School WASH accessibility audit report and suggestions for improving accessibility for children with disabilities

Brief visits and accessibility audits were conducted to two government primary schools in Addis Ababa on December 15 and 16 2020 by Aino Himanen (COWASH Disability Inclusion Specialist/ Consultant) and Joseph Fekadu (DDI Disability Development Initiative/ Director). The team was accompanied by Eskinder Endreas (SPLASH/ Engineer) and Tseguereda Abraham and Alula Bruck (WaterAid Ethiopia/ Head of Partnerships and Senior Design and Quality Engineer) to their respective schools where they had recently constructed complete WASH facilities.

Photos from the WaterAid/MoE design

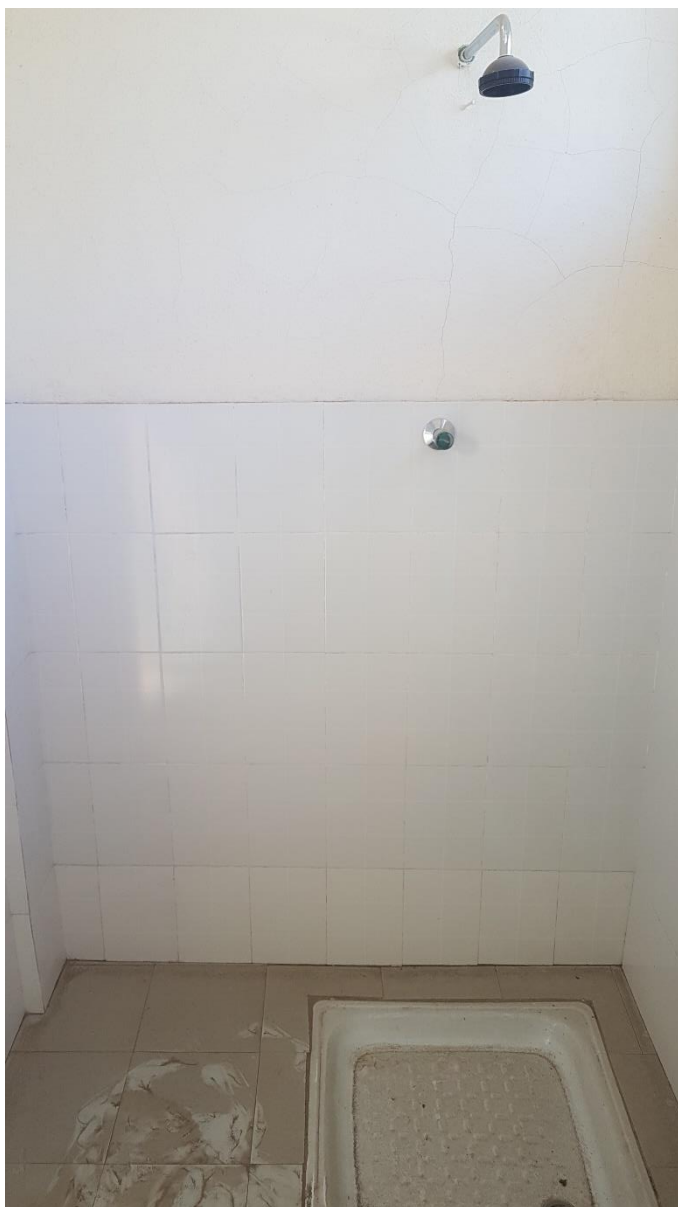
On the left, Joseph in the school latrine demonstrating that it is impossible to turn around in the wheelchair or to get on the toilet seat. On the right, the even smaller space of the KG accessible toilet. Below, the doors and beds blocking the way to the shower in the MHM room.

The step on the right side of the shower makes it impossible to reach the shower seat. The handrail on the left may help some, but it is not enough for a wheelchair user to be able move him or herself to the seat.

- The latrine
 - There is not enough space to move around the accessible room. The toilet seat should be placed in the corner opposite from the door, not in front of it.
 - There should be a handrail on both sides of the toilet seat, to have one on only one side is not enough.
 - The handrail on the wall should be parallel to the floor, not at a diagonal and it should be lower.
- The KG latrine
 - The room for children with disabilities has to be bigger. There is not enough space now, especially if someone needs to assist or lift the child.
 - Some of the handwashing facilities could not be reached due to steps
- The MHM facility:

- The way to the shower room is blocked by the beds in the resting room. The room size should be checked if the standard size mattresses/beds do not fit without blocking the doors.
- The shower room has space, but it is not possible to use the shower due to the step (raised shower basin). There is a handrail and a seat but due to the step it is not possible to reach the seat.
- Similarly as in the latrine, the handrail should be parallel to the floor
- Generally, it would be better to also have a tap at a lower height for easier access to water if a girl wants to only wash part of the body but not take a full shower.
- The drinking water station in the school compound
 - The ramp should be placed in front of the (lower) tap, meant for the child with disabilities. Now there is not enough space to reach the tap due to the ramp location.
